MODIFICATION 01 - JUNE 2020
SCHEDULE OF CHANGES

MOD2020/0334

PROJECT
32 The Strand
Whale Beach, NSW, 2107
Lot 70 on DP11067

PHASE
DA
DWG NO
210.01
REV
C
schematic design

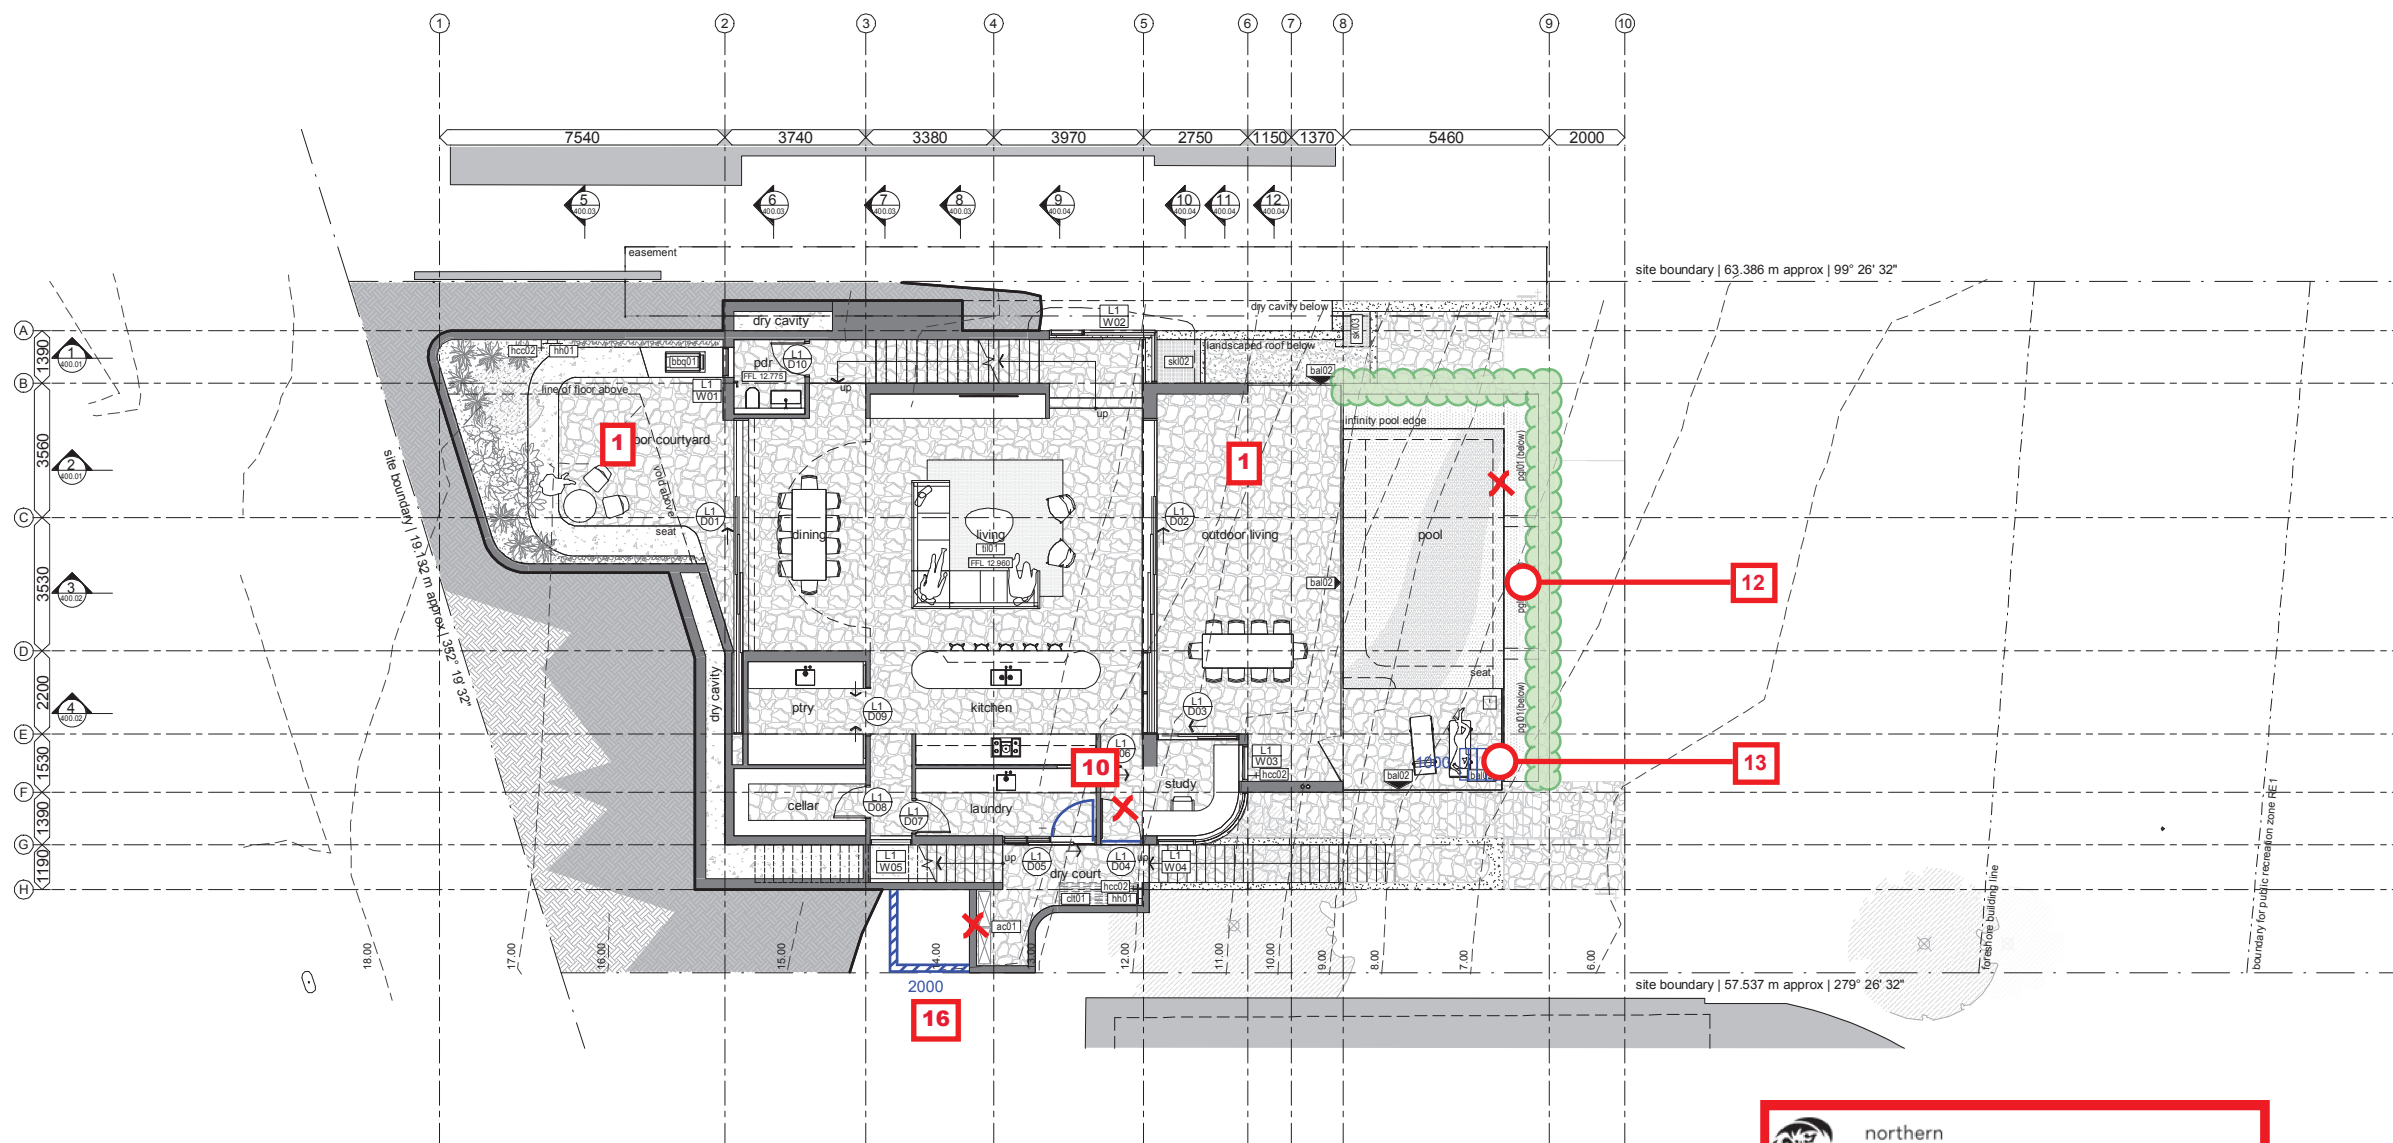
- Typical to all external areas: stone floor paving substituted for conventional shaped natural stone tile
- Typical to all internal areas: stone floor paving substituted for timber floors, and conventional shaped natural stone tiles in wet areas

- Hard path and steps removed from architectural scope. Soft landscaping solution by landscape architect
- Driveway finish changed and widened in accordance with consent SL2020/0241

- Driveway levels modified to suit Council requirements in accordance with consent SL2020/0241. Car turntable added
- Garage level raised by 300mm to RL17.700 as a result of accommodating [5]

- Garage roof and garden edge lifted 150mm to RL20.850 as a result of accommodating [5] and [6].
- Main roof ridge lowered by 290mm to RL22.750 as a courtesy to improve the view amenity of a neighbour to the west. Roof slope adjusted to 11.6 degrees.

- Bin store reshaped and curved wall deleted. Bin store lid level shown at RL20.150. Refer to plans for dims where appropriate. Alteration in part as a result of compliance with prescribed conditions of consent (23) + (25) relating to tree protection and arborist's recommendations.

- Minor alteration to configuration of glazing. Fixed glass to study. Glazed swing door out of laundry. Note net area and amount of glass remains unchanged.

- Minor alteration to configuration of glazing. Refer to plan for relocation of walls. Note net area and amount of glass remains unchanged. floor area slightly reduced.

- Swimming pool infinity edges (and associated ballast tank) deleted and zone changed to accessible path and landscaped wall/planter
- Steps introduced to pool terrace to access service path. Refer to plans for dims where appropriate.

- Extra solar panels added to increase energy efficiency of development
- Block wall moved down to align with pool equipment adjacent as shown. Note this change is underground and not visible to the public or neighbours.

- Plant and equipment store area increased by moving western wall further west in order to accommodate the required equipment with ventilation and service space. Refer to plans for dims where appropriate.

- Block wall to be changed to screening for ventilation and sound attenuation
- Seat added
- Landscape plan amended in accordance with prescribed conditions of consent (15) + (38).

- Height of landscaped wall facing street to be increased to the North to a max height of 1800mm above ground level to follow natural topography.

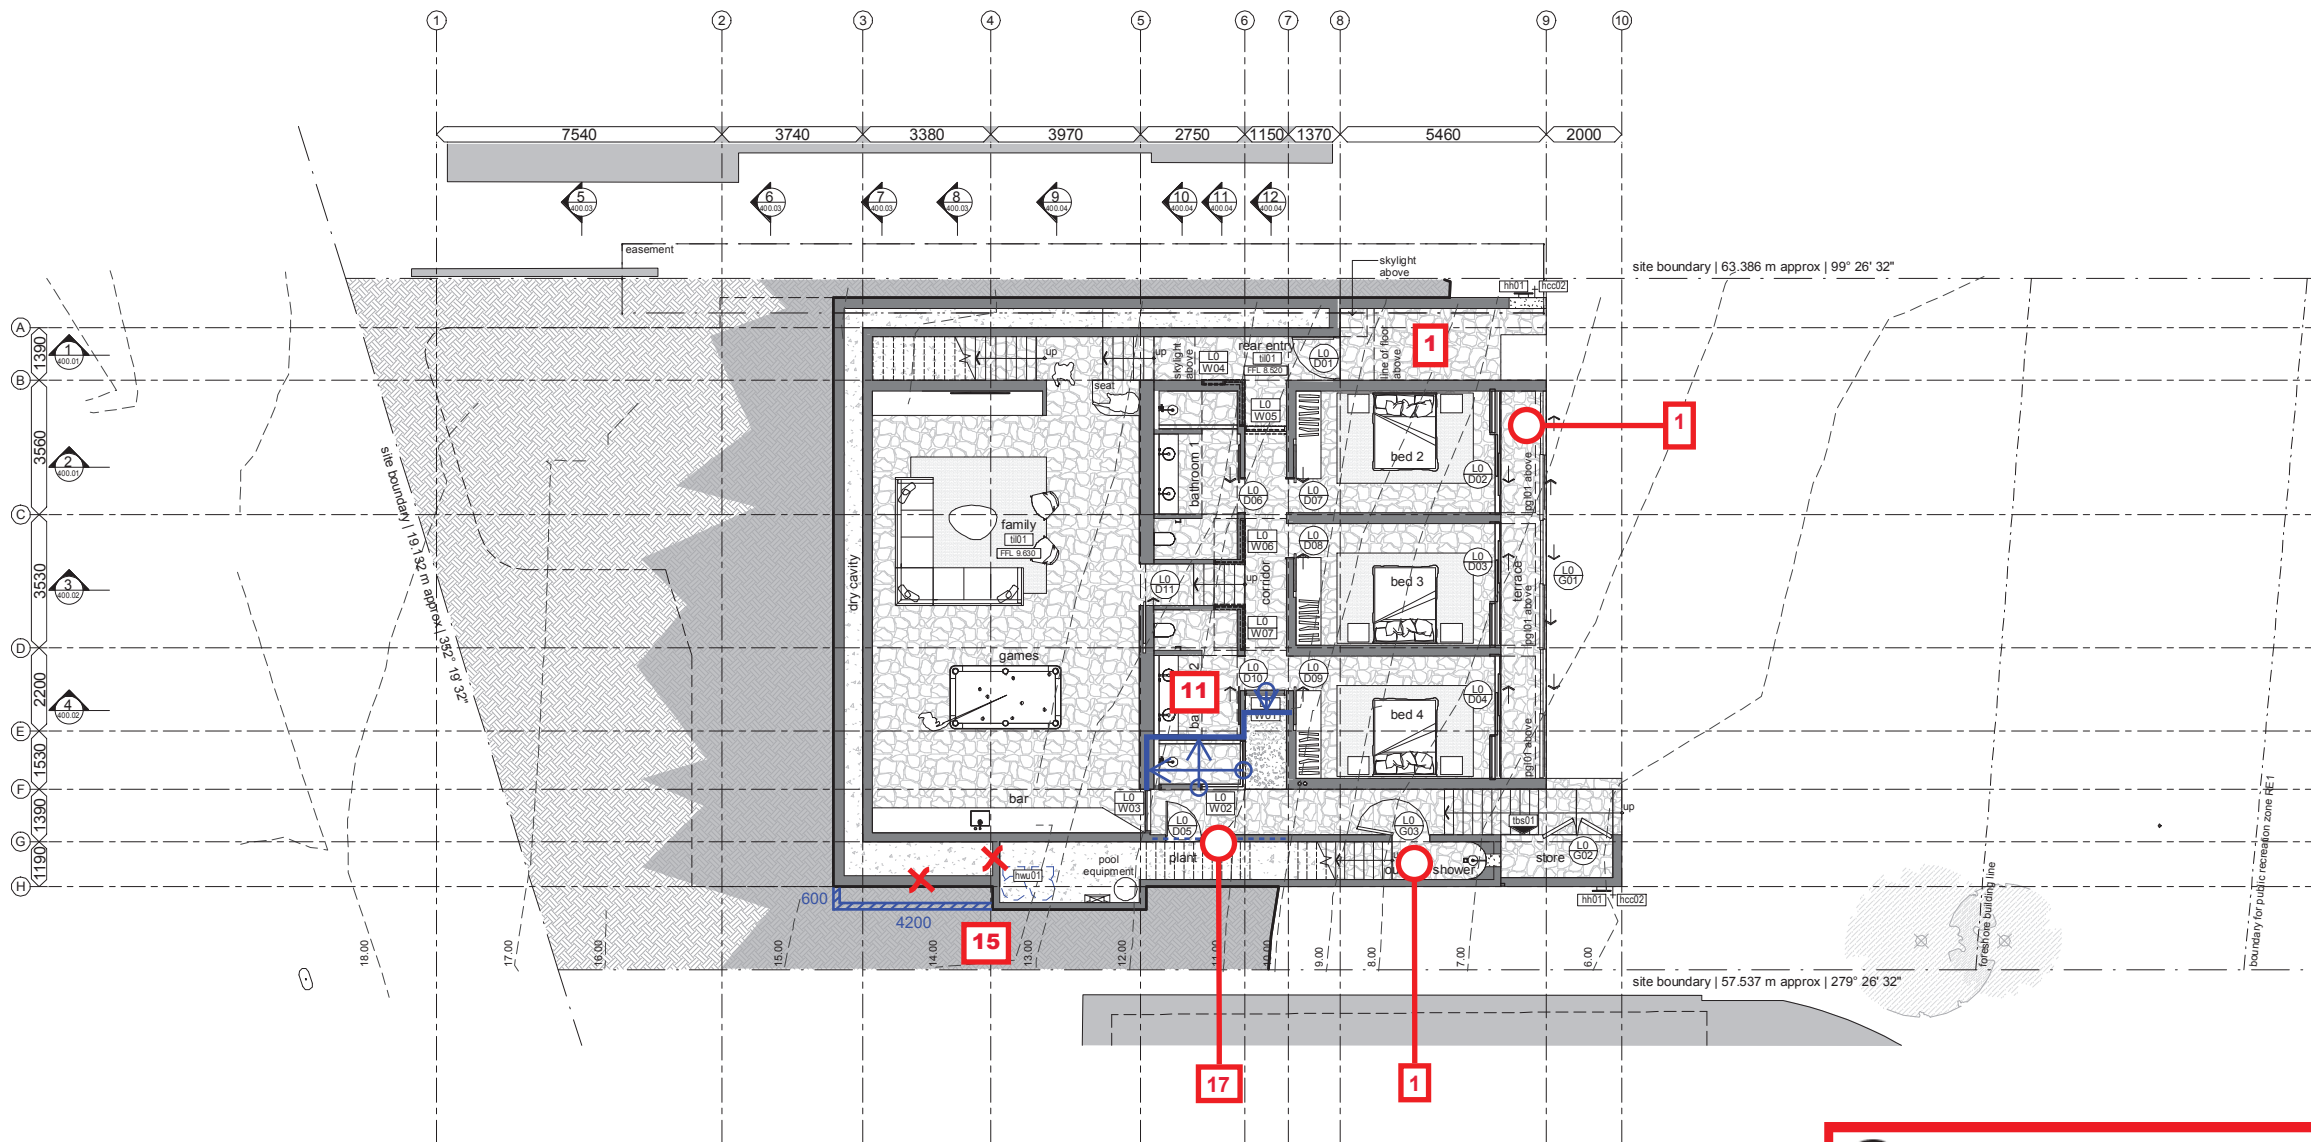
- Typical to all external areas: stone floor paving substituted for conventional shaped natural stone tile
- Typical to all internal areas: stone floor paving substituted for timber floors, and conventional shaped natural stone tiles in wet areas

- Hard path and steps removed from architectural scope. Soft landscaping solution by landscape architect
- Driveway finish changed and widened in accordance with consent SL2020/0241

- Driveway levels modified to suit Council requirements in accordance with consent SL2020/0241. Car turntable added
- Garage level raised by 300mm to RL17.700 as a result of accommodating [5]

- Garage roof and garden edge lifted 150mm to RL20.850 as a result of accommodating [5] and [6].
- Main roof ridge lowered by 290mm to RL22.750 as a courtesy to improve the view amenity of a neighbour to the west. Roof slope adjusted to 11.6 degrees.

- Bin store reshaped and curved wall deleted. Bin store lid level shown at RL20.150. Refer to plans for dims where appropriate. Alteration in part as a result of compliance with prescribed conditions of consent (23) + (25) relating to tree protection and arborist's recommendations.

- Minor alteration to configuration of glazing. Fixed glass to study. Glazed swing door out of laundry. Note net area and amount of glass remains unchanged.

- Minor alteration to configuration of glazing. Refer to plan for relocation of walls. Note net area and amount of glass remains unchanged. floor area slightly reduced.

- Swimming pool infinity edges (and associated ballast tank) deleted and zone changed to accessible path and landscaped wall/planter
- Steps introduced to pool terrace to access service path. Refer to plans for dims where appropriate.

- Extra solar panels added to increase energy efficiency of development
- Block wall moved down to align with pool equipment adjacent as shown. Note this change is underground and not visible to the public or neighbours.

- Plant and equipment store area increased by moving western wall further west in order to accommodate the required equipment with ventilation and service space. Refer to plans for dims where appropriate.

- Block wall to be changed to screening for ventilation and sound attenuation
- Seat added
- Landscape plan amended in accordance with prescribed conditions of consent (15) + (38).

- Height of landscaped wall facing street to be increased to the North to a max height of 1800mm above ground level to follow natural topography.

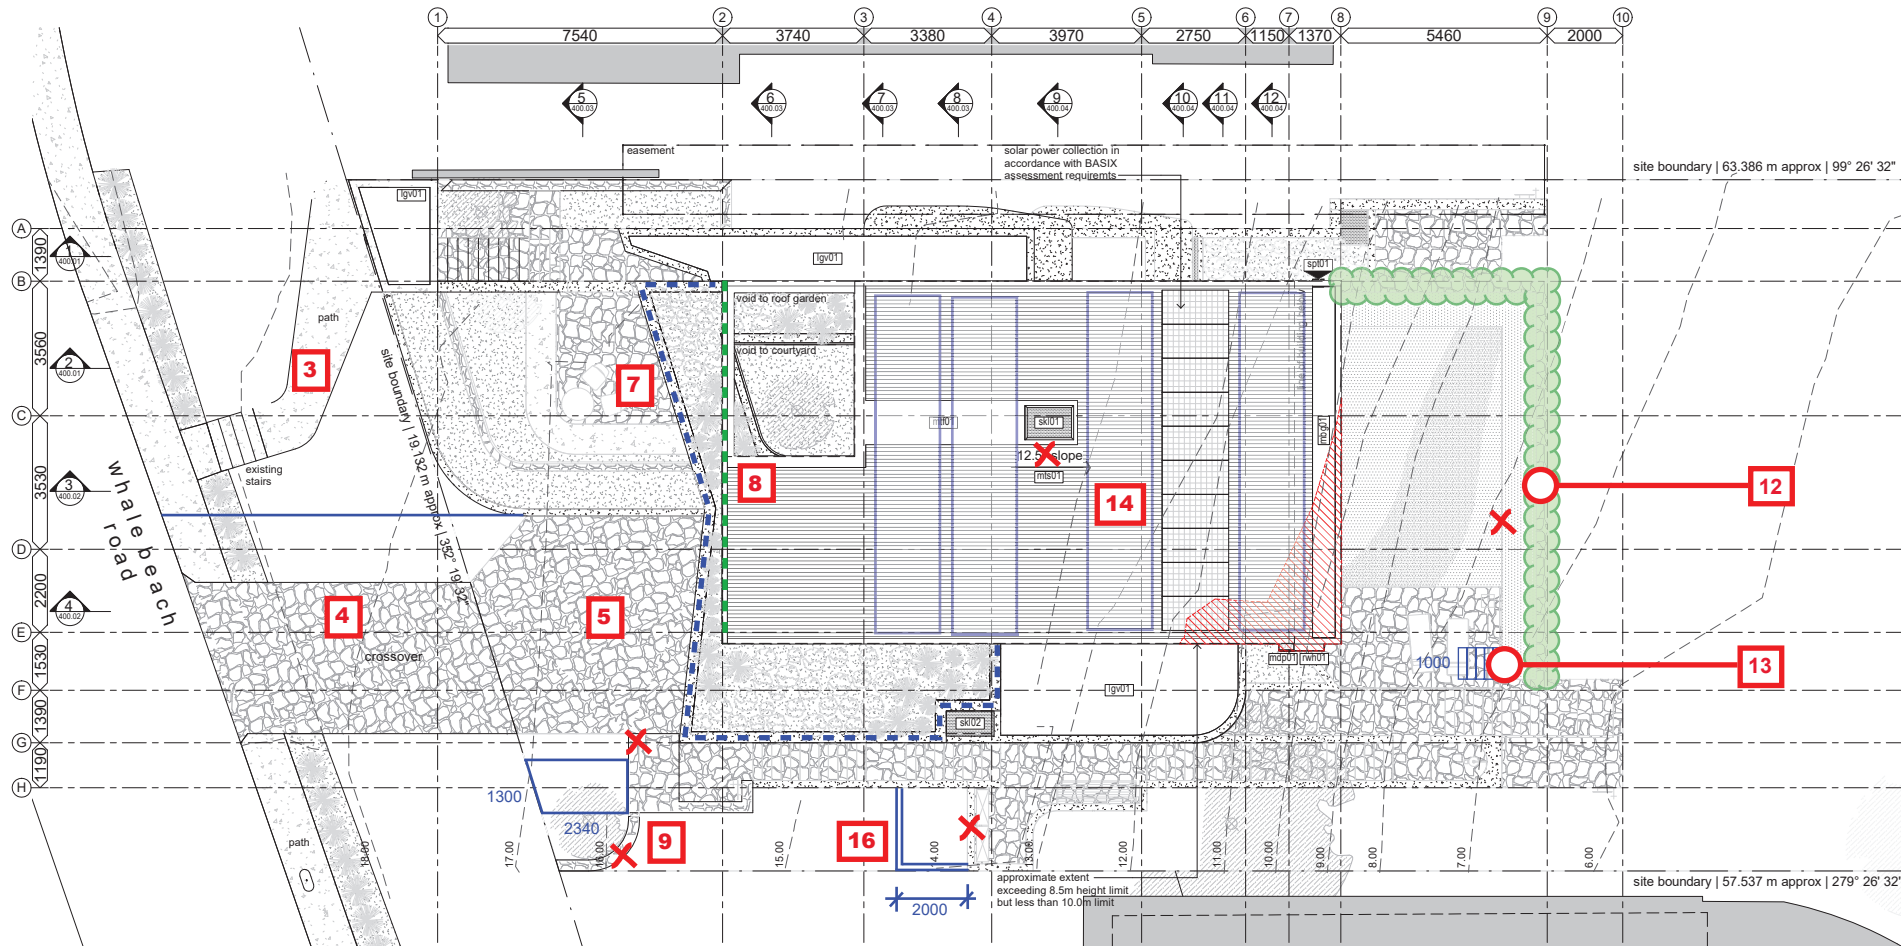
1. Typical to all external areas: stone floor paving substituted for conventional shaped natural stone tile
2. Typical to all internal areas: stone floor paving substituted for timber floors, and conventional shaped natural stone tiles in wet areas

3. Hard path and steps removed from architectural scope. Soft landscaping solution by landscape architect
4. Driveway finish changed and widened in accordance with consent SL2020/0241

5. Driveway levels modified to suit Council requirements in accordance with consent SL2020/0241. Car turntable added
6. Garage level raised by 300mm to RL17.700 as a result of accommodating [5]

7. Garage roof and garden edge lifted 150mm to RL20.850 as a result of accommodating [5] and [6].
8. Main roof ridge lowered by 290mm to RL22.750 as a courtesy to improve the view amenity of a neighbour to the west. Roof slope adjusted to 11.6 degrees.

9. Bin store reshaped and curved wall deleted. Bin store lid level shown at RL20.150. Refer to plans for dims where appropriate. Alteration in part as a result of compliance with prescribed conditions of consent (23) + (25) relating to tree protection and arborist's recommendations.

10. Minor alteration to configuration of glazing. Fixed glass to study. Glazed swing door out of laundry. Note net area and amount of glass remains unchanged.

11. Minor alteration to configuration of glazing. Refer to plan for relocation of walls. Note net area and amount of glass remains unchanged. floor area slightly reduced.

12. Swimming pool infinity edges (and associated ballast tank) deleted and zone changed to accessible path and landscaped wall/planter
13. Steps introduced to pool terrace to access service path . Refer to plans for dims where appropriate.

14. Extra solar panels added to increase energy efficiency of development
15. Block wall moved down to align with pool equipment adjacent as shown. Note this change is underground and not visible to the public or neighbours.

16. Plant and equipment store area increased by moving western wall further west in order to accommodate the required equipment with ventilation and service space. Refer to plans for dims where appropriate.

17. Block wall to be changed to screening for ventilation and sound attenuation
18. Seat added
19. Landscape plan amended in accordance with prescribed conditions of consent (15) + (38).

20. Height of landscaped wall facing street to be increased to the North to a max height of 1800mm above ground level to follow natural topography.
